Decking upgrade Former Mobile Shop Stimpson Lumber Mill Libby, Montana

235 N. First St. West Missoula, MT 59802 Second Floor Ph; (406) 721-5733 www.eclipse-engineering.com STIMPSON LUMBER MILL ROOF DECKING UPGRADE

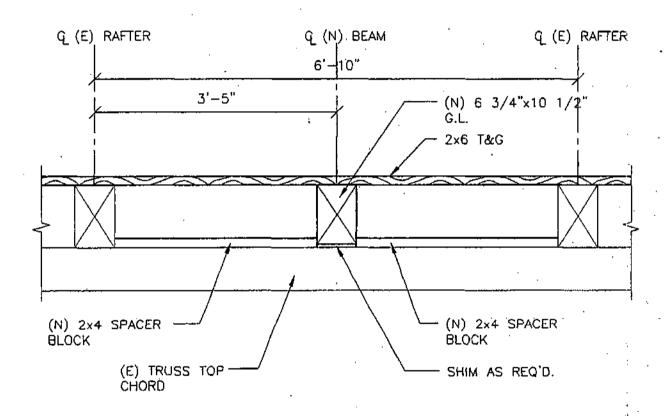
As indicated in our "Pre-removal roof occupancy assessment" letter, dated 01/24/05, we have coordinated a cost effective eption to upgrade the existing roof decking in order to support construction loads. The upgrade shall be per the attached "Roof Framing Plan", sheet 1 of 2. New, (N), 6 ¾" x 10 ½" glu-lam roof rafters shall be placed in between each existing, (E), 8x12 roof rafters. These beams shall be installed prior to placing workers on the roof. Reference attached detail A, sheet 2 of 2, for (N) rafter to (E) truss connection. These (N) rafters on the attached "Roof Framing Plan", sheet 1 of 2, are shown, for clarity, to be in one location only but shall be used throughout the entire roof area.
